License # DPR 31 & 41 Amend: Proposed change to tech specs consisting of revisions concerning tendon inspections.....
notarized 9-29-77.....

PLANT NAME: Turkey Point 3 & 4

Re: Turkey Point Unit Nos. 3 & 4
Docket Nos. 50-250 and 50-251
Proposed Amendment to Facility
Operating Licenses DPR-31 and DPR-41

FLORIDA POWER & LIGHT CO.
 TURKEY POINT NUCLEAR POWER PLANT
 UNIT 3
 POST-TENSIONING SYSTEM
 SURVEILLANCE TENDONS
 LOCATION AND IDENTIFICATION
 FIGURE 1

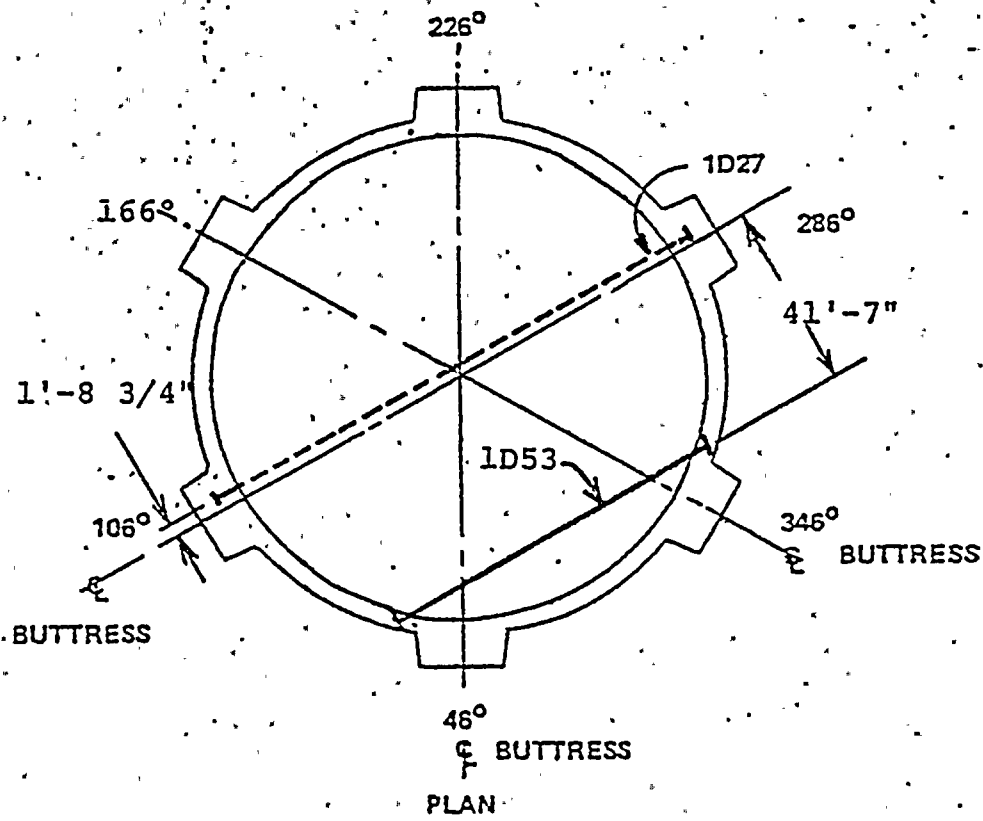
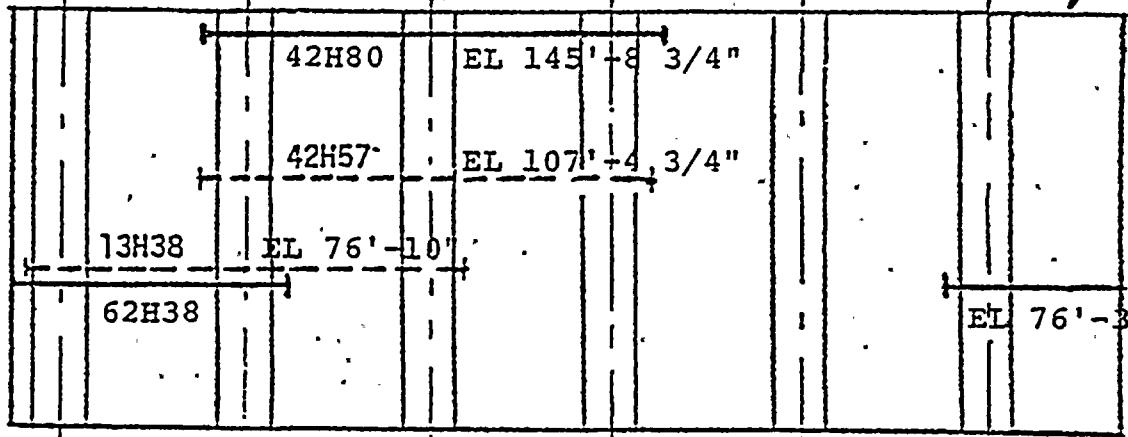
This evaluation supports a proposed change to Technical Specification 4.4.6 (Tendon Surveillance). The list of Unit 3 tendons is revised to delete tendons 64H50 & 1D27, and add 64H51 & 1D53. The list of Unit 4 tendons is revised to delete tendons 13H38, 42H57 & 2D14, and add 62H38, 42H80 & 2D3.

Tendons 64H50 and 64H51 are both located between azimuths 226° and 346° . Tendon 64H50 is at elevation 96'-10" and tendon 64H51 is at elevation 98'-6". Since both tendons are located between the same azimuths at approximately the same elevation, they experience essentially the same environmental conditions.

Two wires have been removed from tendon 64H51, but no wires have been removed from 64H50. Since both tendons are in approximately the same location, wire samples from either one would satisfy the intent of Specification 4.4.6. There are no structural safety related consequences associated with having tested tendon 64H51 instead of 64H50.

Tendons 1D27 and 1D53 are from the same dome group, have their ends anchored at approximately the same elevations within the same 60-degree angles, and experience essentially the same environmental conditions. Since the influences on both tendons are approximately equal, wire samples from either one would satisfy the intent of Technical Specification 4.4.6. Two wires have been removed from tendon 1D27, but as discussed above, there are no structural safety related consequences associated with terminating the surveillance of 1D27 and instead surveilling 1D53. Thus, substituting tendon 1D53 for 1D27 will meet FSAR commitments and will not compromise the inservice tendon inspection program.

Figures 1 and 2 show the original and proposed surveillance tendons. An examination of these figures shows that the proposed surveillance tendons will experience a full environmental exposure.

FLORIDA POWER & LIGHT CO.
TURKEY POINT NUCLEAR POWER PLANT
UNIT 4
POST-TENSIONING SYSTEM
SURVEILLANCE TENDONS
LOCATION AND IDENTIFICATION

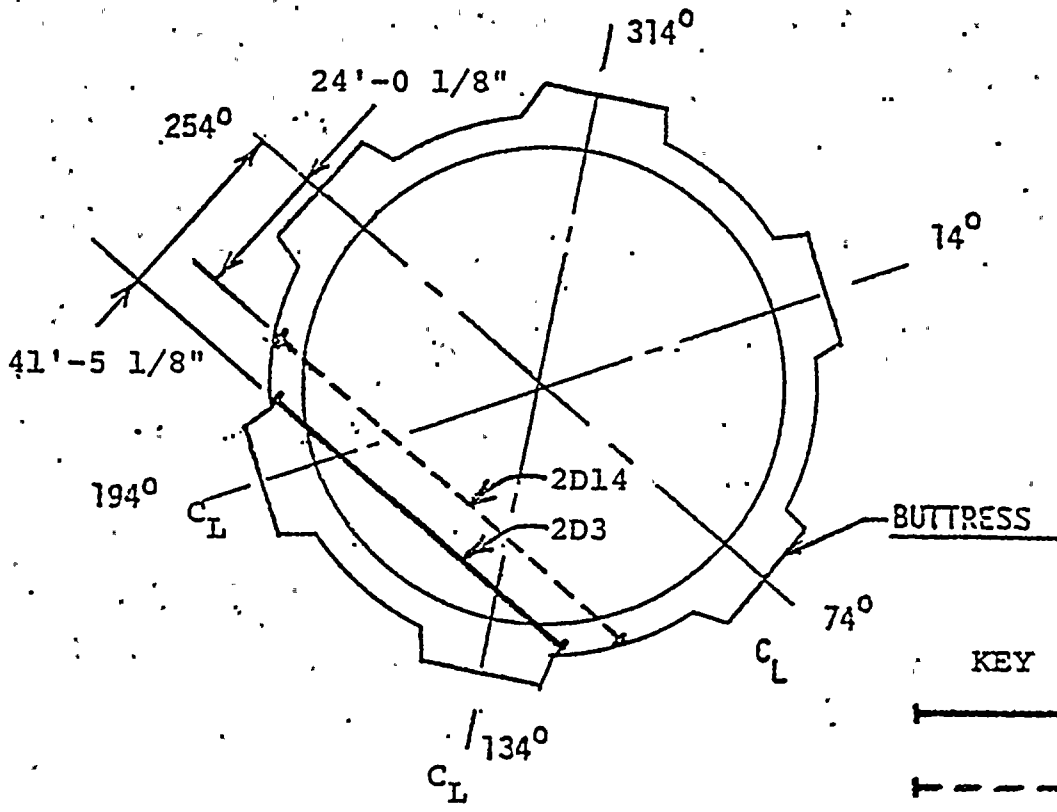
Tendon 42H80 and 42H57 are both located between azimuths 314° and 74°. Tendon 42H80 is located at elevation 145'-8 3/4" and tendon 42H57 is located at elevation 107'-4 3/4". Although the change in elevation is notable, it is felt to be insignificant with regard to environmental exposure and is necessary to protect the personnel performing the surveillance. There have been no wires removed from 42H57. Thus, the substitution of tendon 42H80 in lieu of 42H57 will continue to meet FSAR commitments and will not compromise the inservice inspection program.

Tendon 62H38 is located between azimuths 74° and 194° at elevation 76'-3 5/8". Tendon 13H38 is located between azimuths 14° and 134° at elevation 76'-10". The tendons are at approximately the same elevation, however, the butress anchorage locations are shifted 60-degrees and might thus experience slightly different environmental exposure. Nevertheless, the change is deemed beneficial in that the new group of horizontal tendons will comprise one complete hoop and will thus provide more representative information during future surveillances. Two wires have been removed from tendon 13H38, but as discussed above, there are no structural safety related consequences associated with terminating the surveillance of 13H38 and instead surveilling 62H38.

Tendons 2D3 and 2D14 are from the same dome group, have their ends anchored at approximately the same elevations within the same 60-degree angles, and experience essentially the same environmental

conditions. Since the influences on both tendons are approximately equal, wire samples from either one would satisfy the intent of Technical Specification 4.4.6. There have been no wires removed from 2D14. Thus, substituting tendon 2D3 for 2D14 will meet the FSAR commitments and will not compromise the inservice tendon inspection program.
